Department of Energy
 Richland Operations Office
 P.O. Box 550
 Richland, Washington 99352

REQUEST FOR CLARIFICATION OF BWIP SCR (SCR-13)

As requested by your letter dated February 17, 1983, and discussed with you, M. Gordon, M. Webber, NRC; and R. Baca and J. H. LaRue, Rockwell Basalt Project staff on March 9, 1983, the enclosure states the DOE replies to the eight questions which the NRC noted in the subject letter.

Figure 1

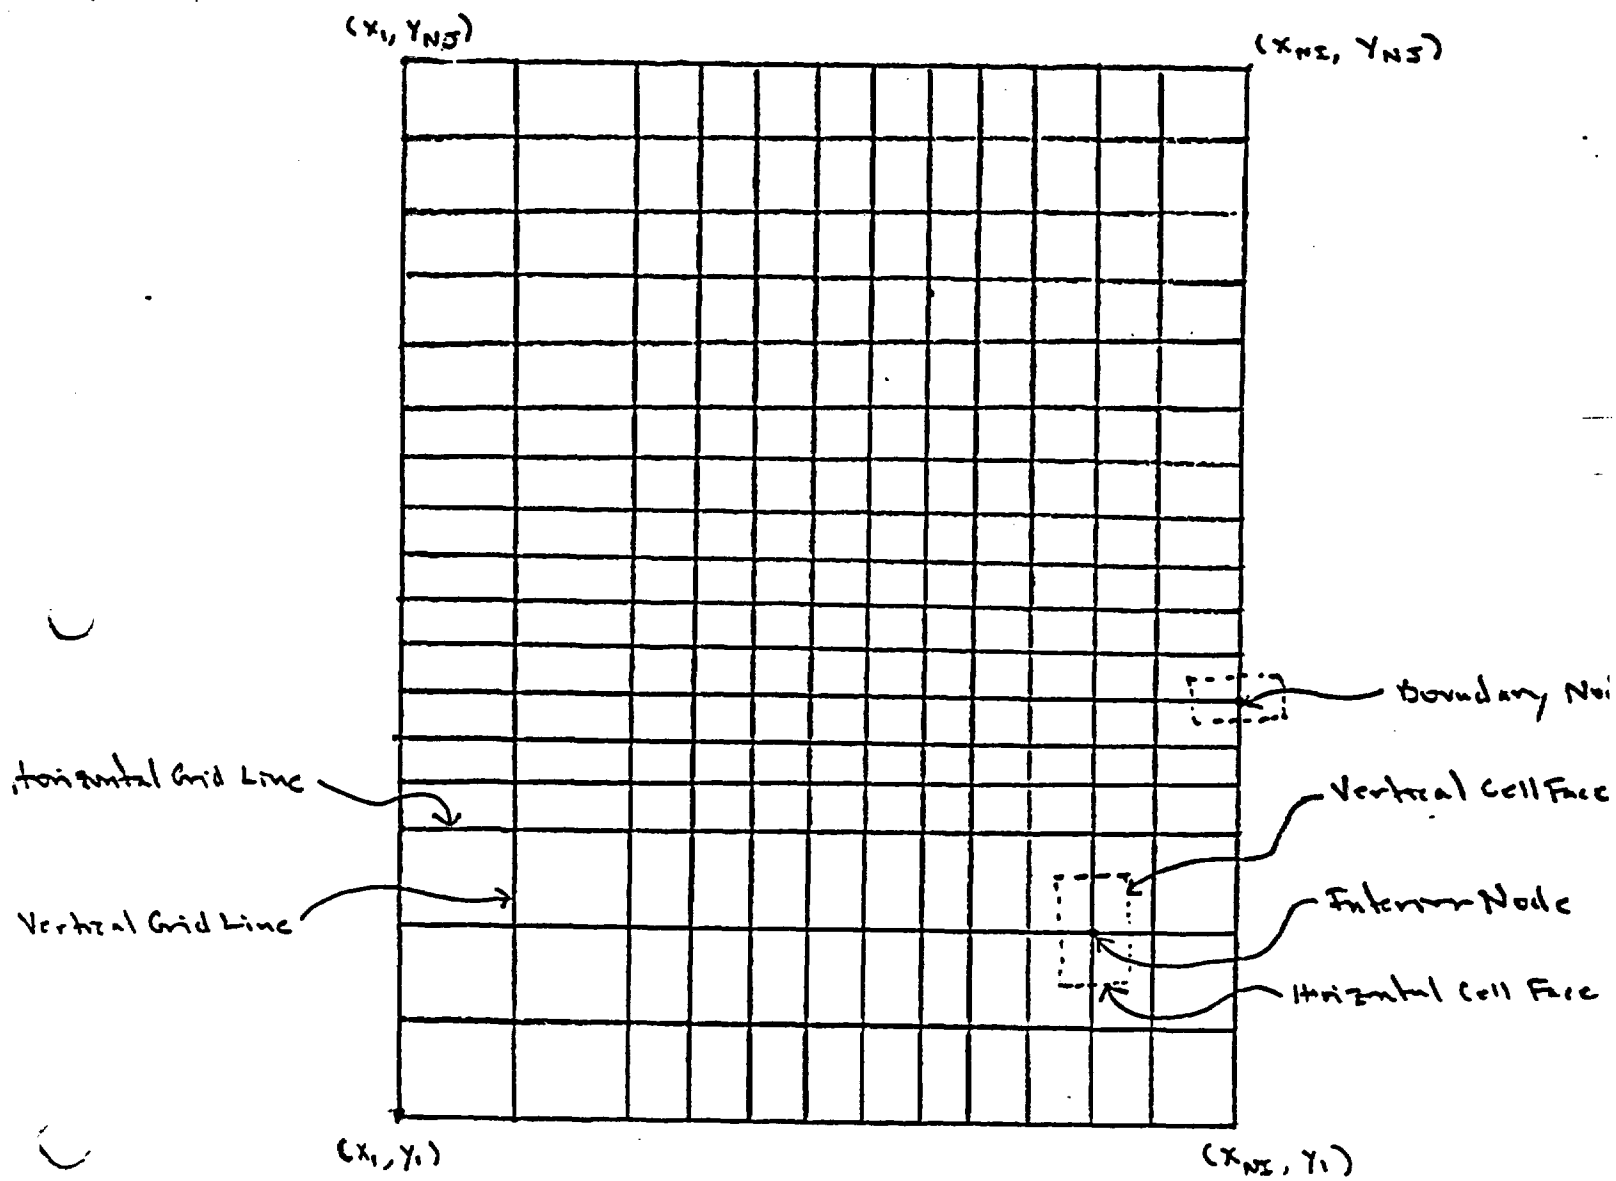
Please specify the precise gridding of the PORFLO model in terms of numbers and lengths of grid blocks in the horizontal and vertical directions.

The PORFLO model uses a rectangular finite difference grid, an example of which is shown in Figure 1. With reference to this figure, definition of some grid components follows. A simple rectangle determined by the intersection of any two adjacent horizontal grid lines with any two adjacent vertical grid lines is called to grid block. Every intersection of two grid lines determines a node. Each interior (boundary) node is the nodal point of a distinct interior (boundary) grid cell. Each horizontal (vertical) interior cell face is midway between two horizontal (vertical) grid lines. Each horizontal (vertical) boundary cell is symmetric about the horizontal (vertical) grid line on which its node lies. A zone is defined as a set of grid cells with the same thermal and hydraulic properties.

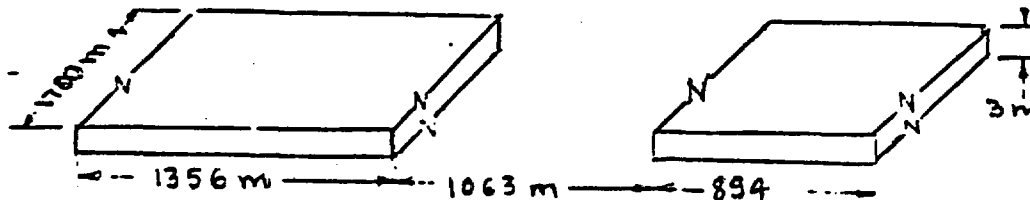
The heat input from the repository in the PORFLO model, sent by the Department of Energy (DOE) to NRC on December 22, 1982, was given in terms of Joules per year per cubic meter. Does this normalized volume include pillar volumes and the host rock between the two repository halves, does it only include the storage areas pictured in Figure 12-13 (BWIP SCR: Ch. 12), is it the volume of the waste packages themselves, or is it a different volume.

These dimensions give a total effective volume of $1.148 \times 10^7 \text{m}^3$. Thus, the peak volumetric heat generation rate is:

In modeling the heat release from the repository, the heat source term was computed for a 47,000 t inventory of 10-yr spent fuel. The initial thermal power output, i.e. power output at $t=0$, was 53,550 kilowatts. The peak "volumetric" heat generation rate ($J/m^3\text{-yr}$) was computed by dividing the initial thermal power output by the effective volume of the repository, i.e. volume of the two repository halves. The effective dimensions of the repository are shown in the sketch below:

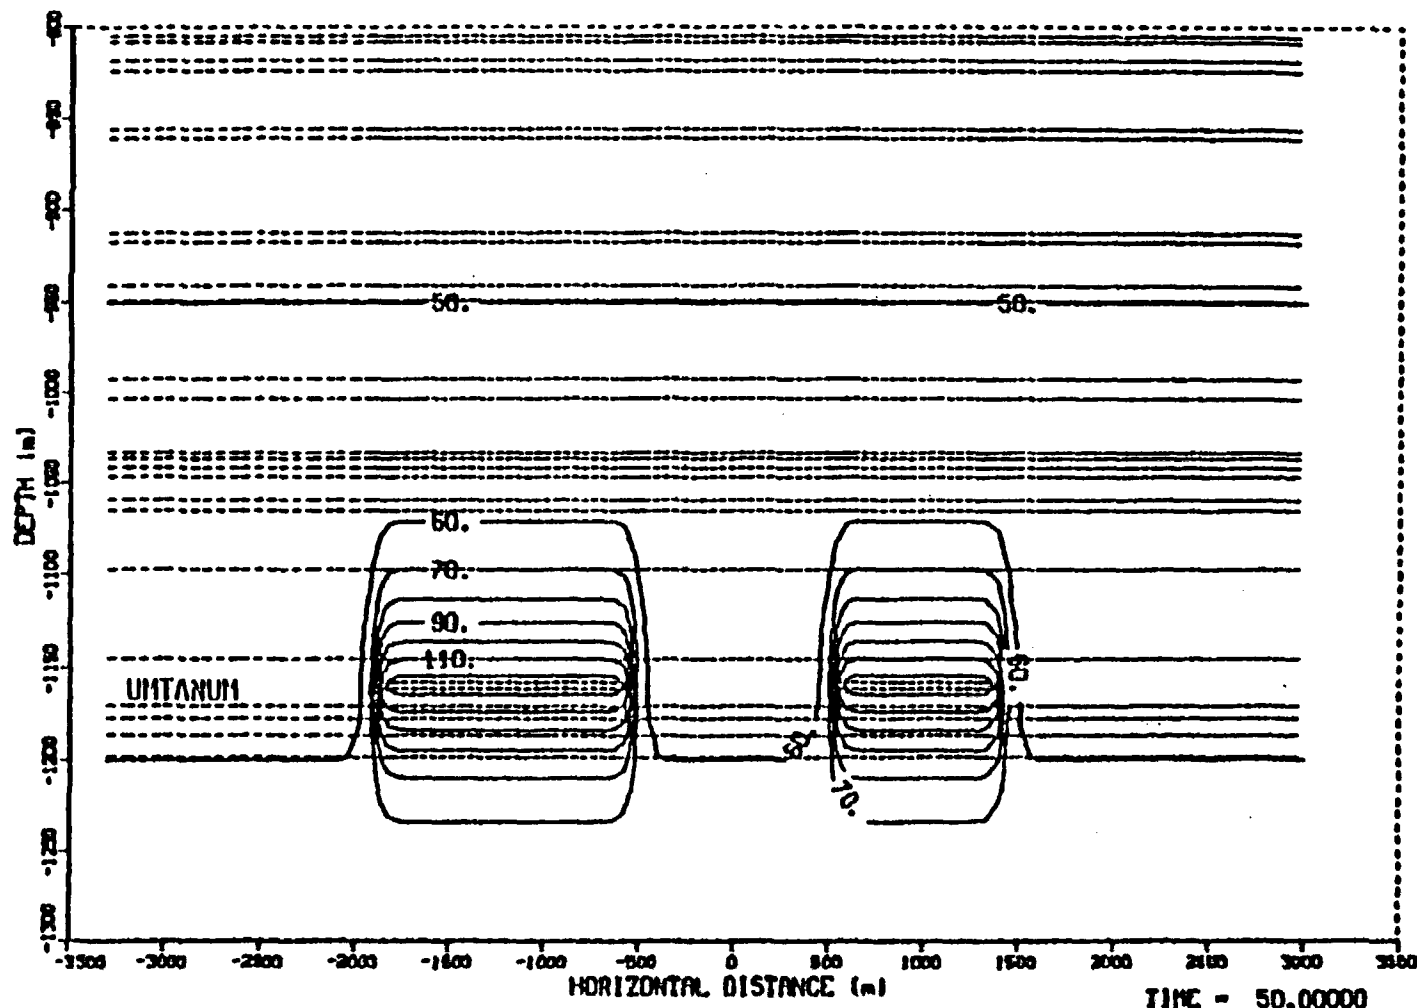
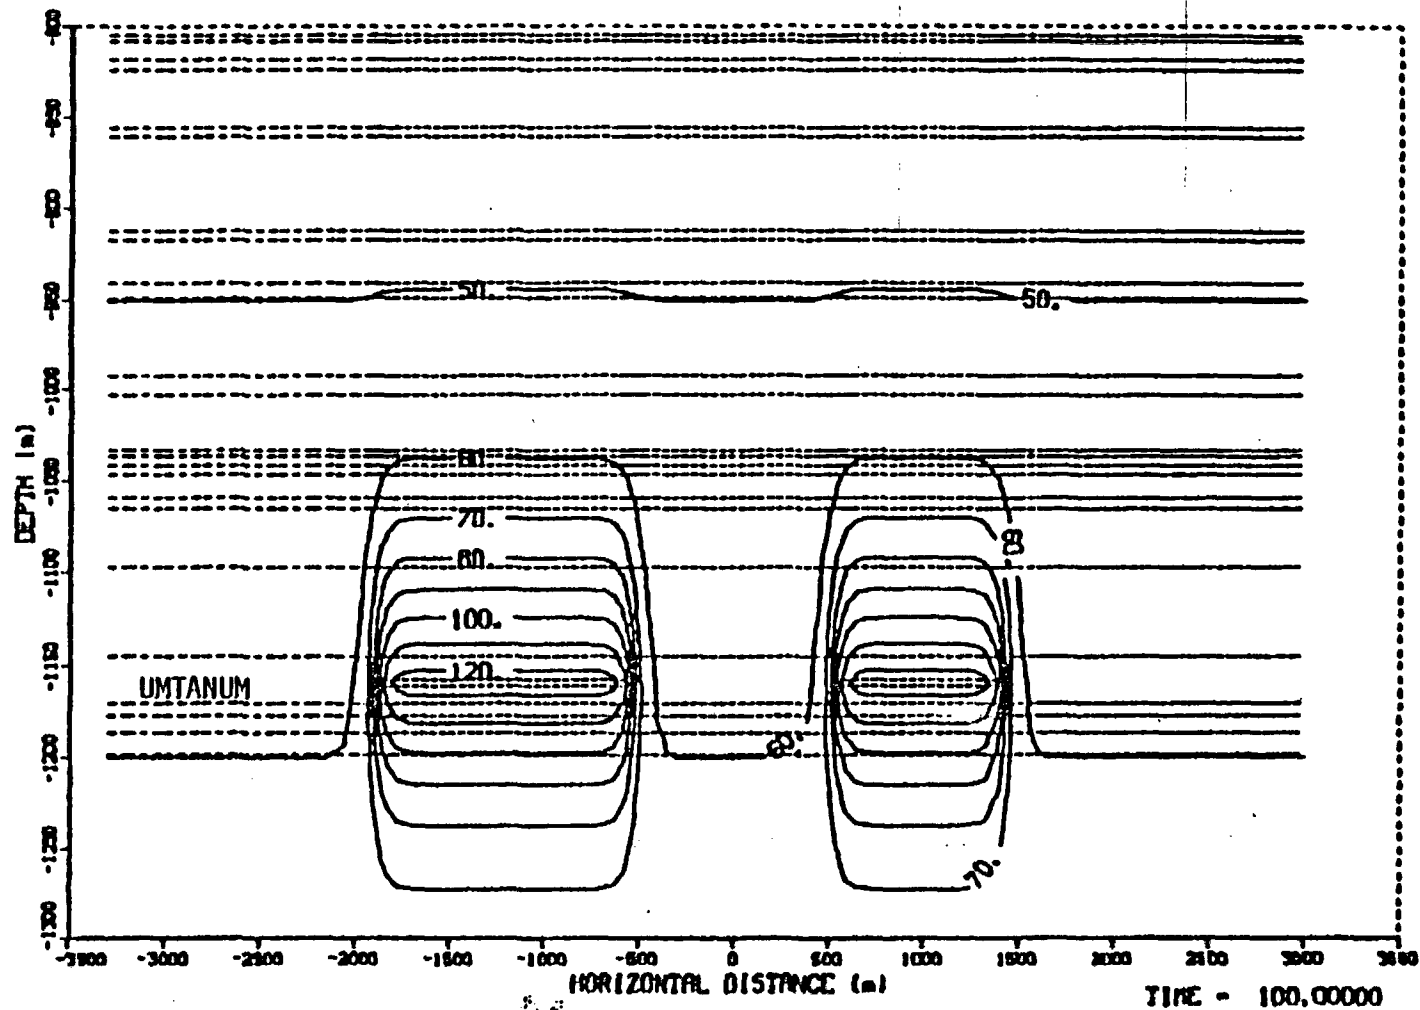
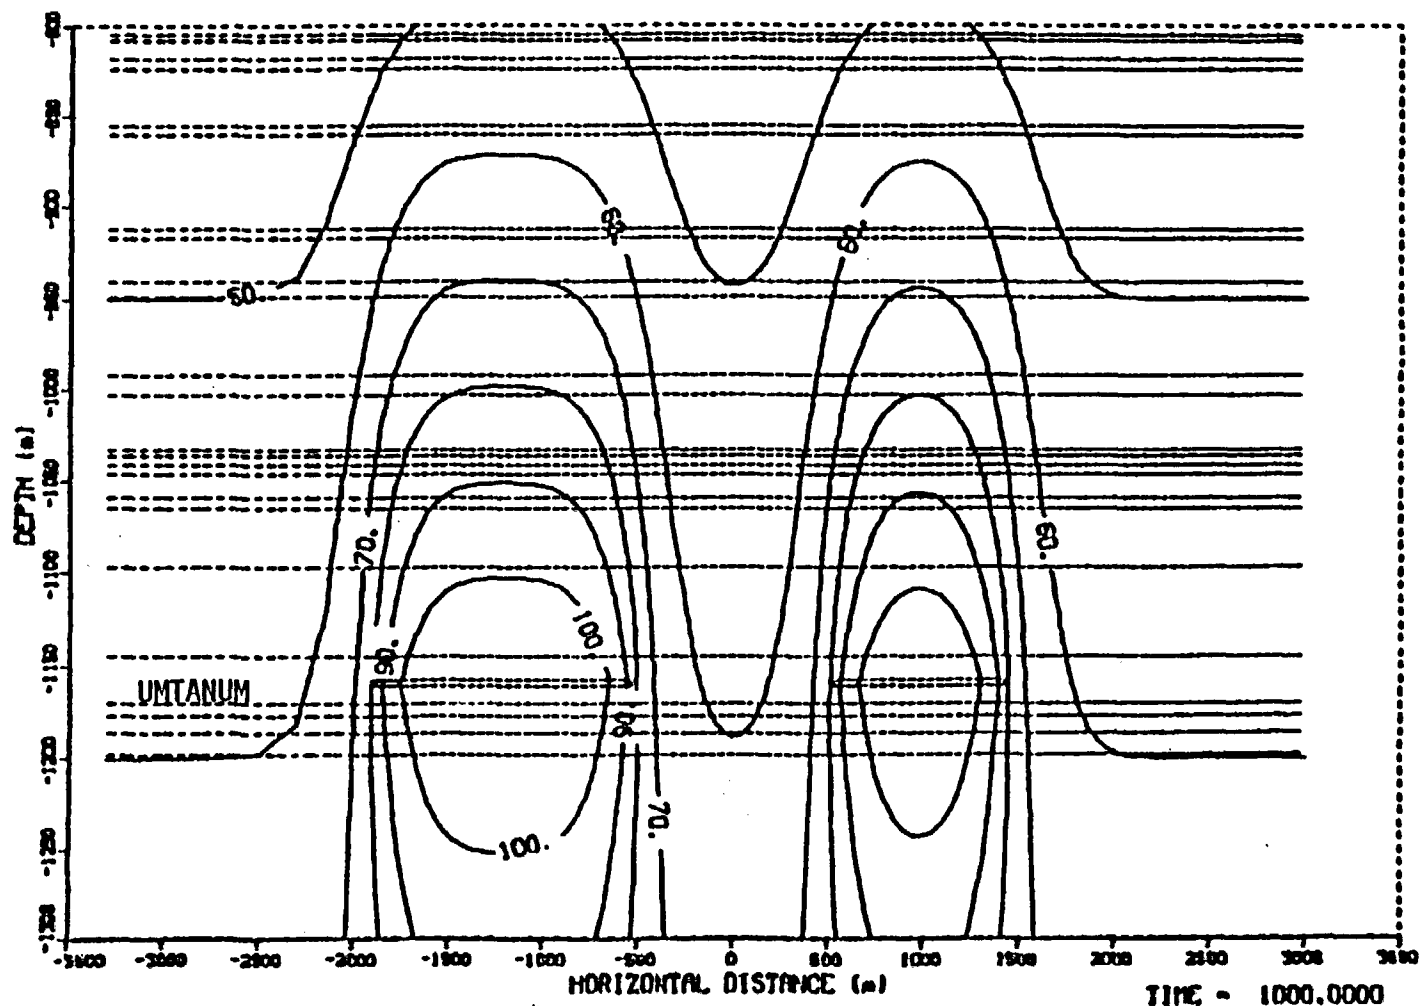
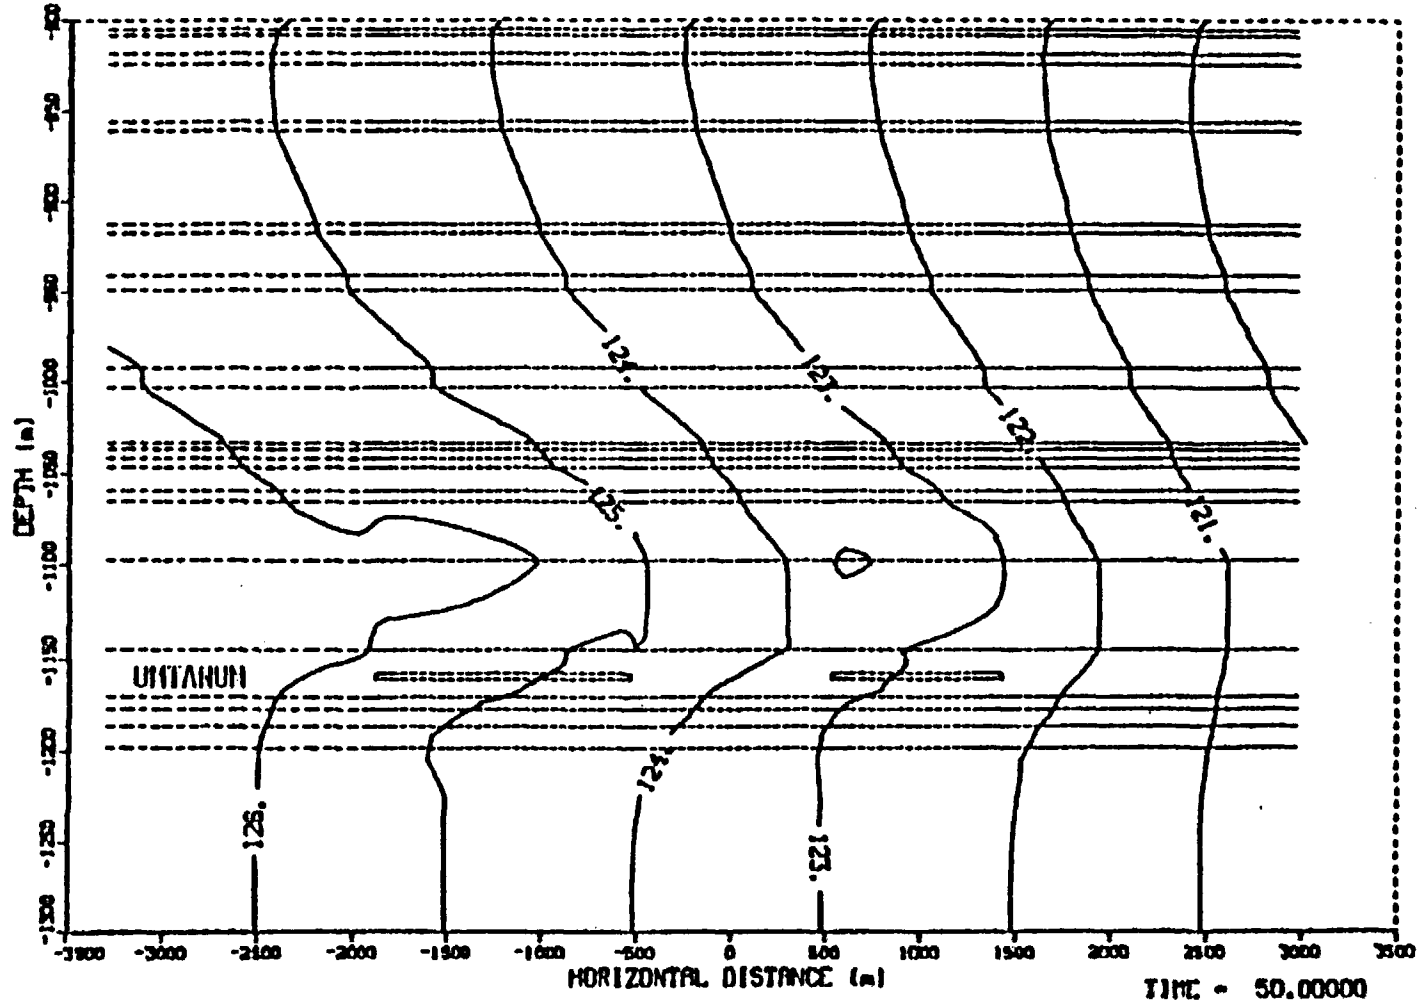
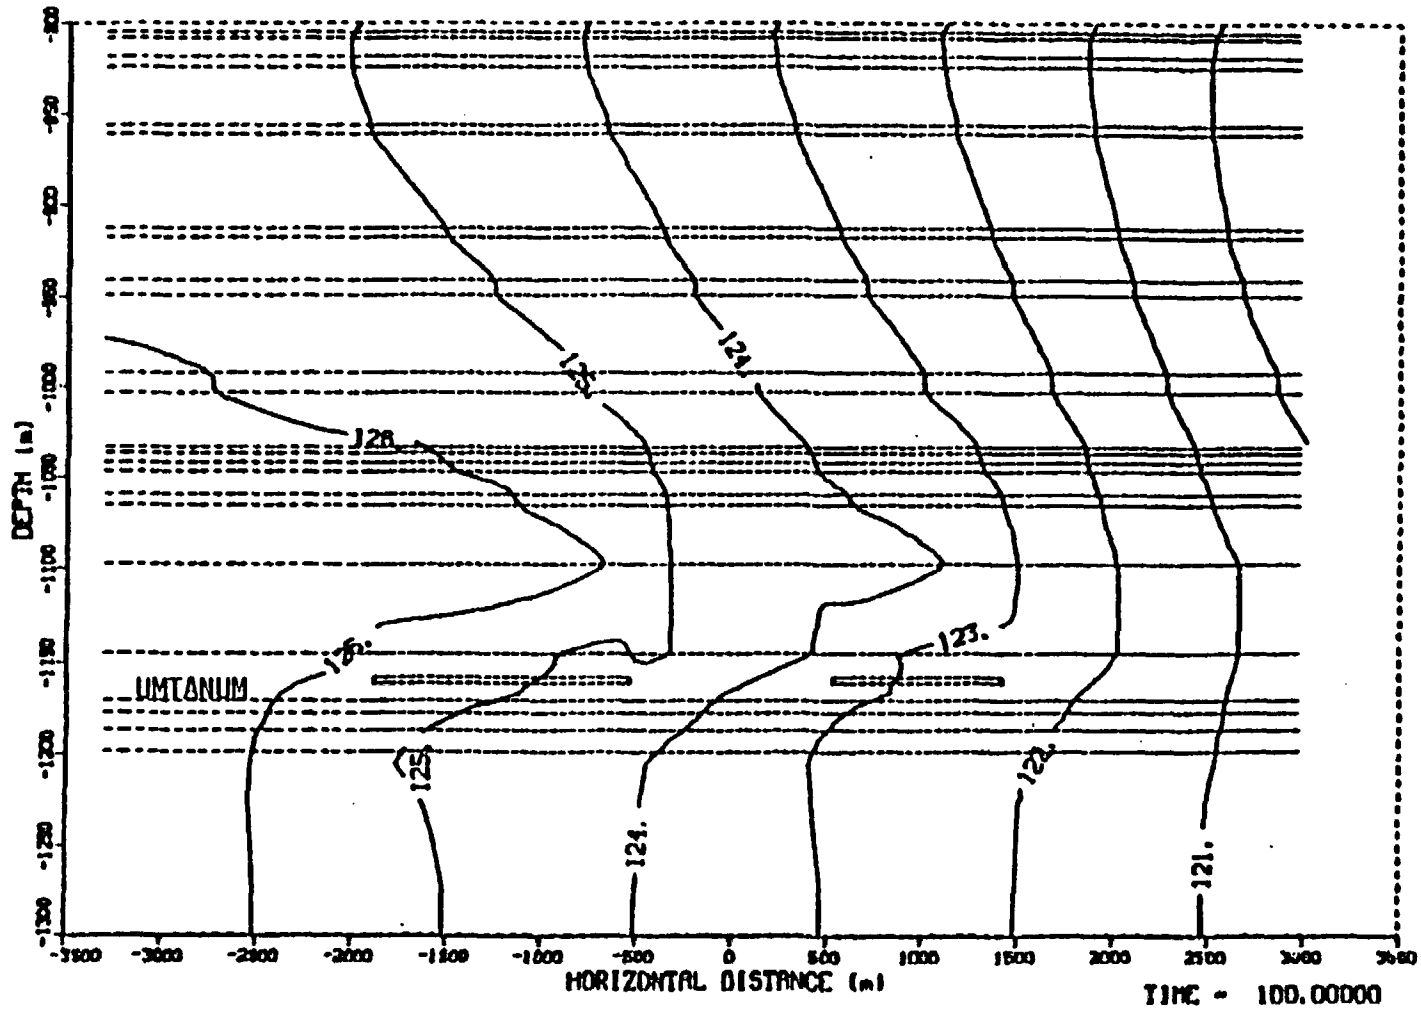
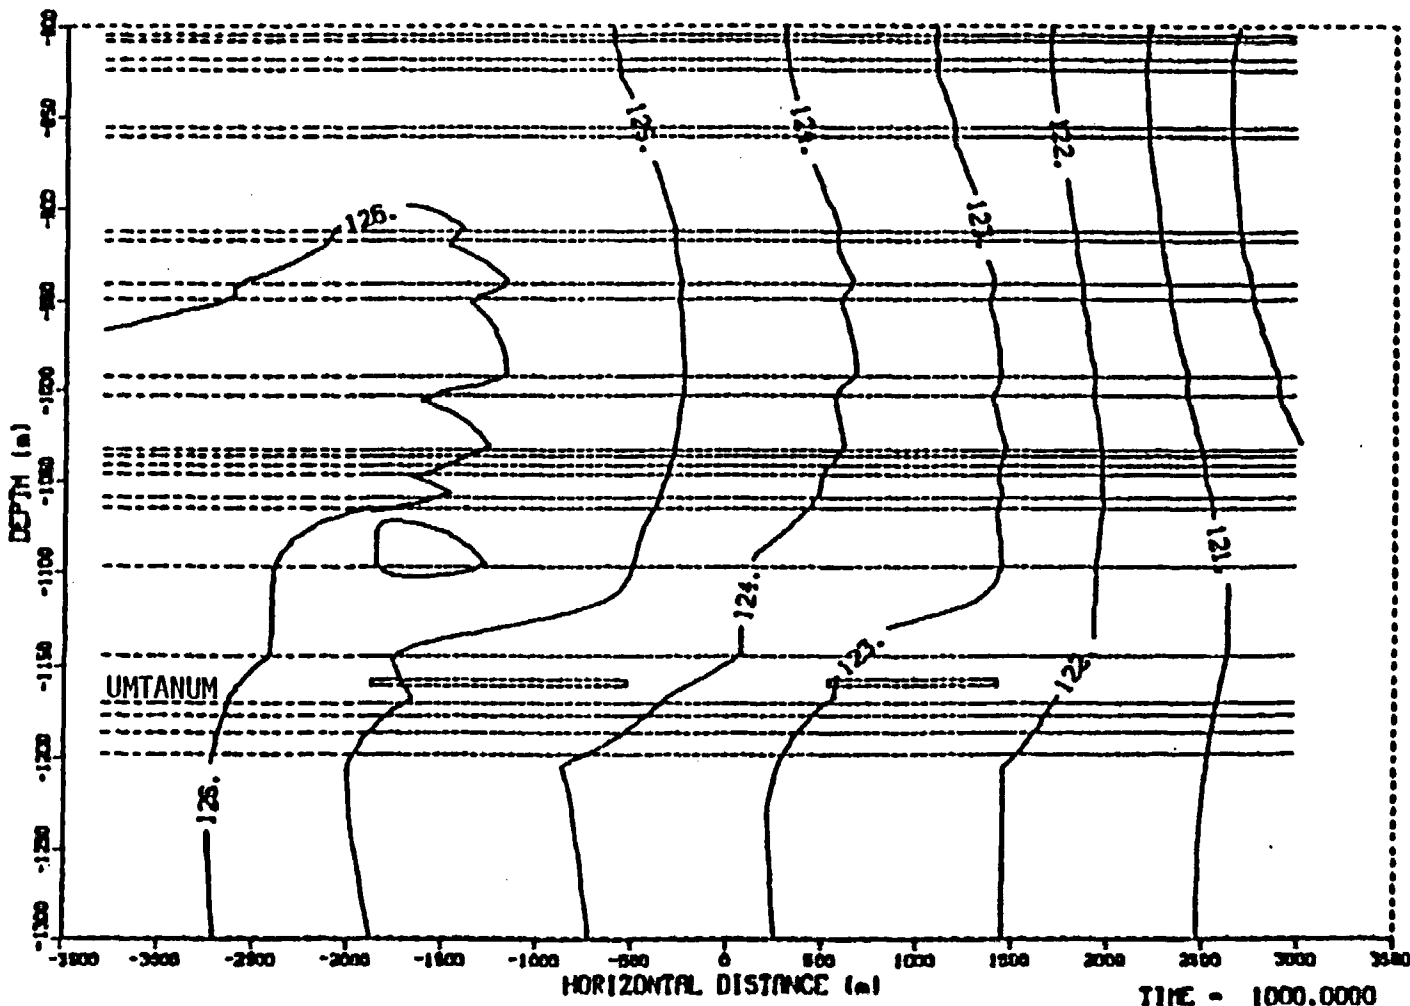
Where does the geothermal gradient (40°C/km) begin in the PORFLO model (eg., at the ground surface, 20 m below, or at the regional water table). What is the temperature, depth and pressure at the repository nodes prior to thermal production by the HLW?

Attached are a series of temperatures (T) and head (h) contour plots which give an indication of the time variations, of T and h around the repository.
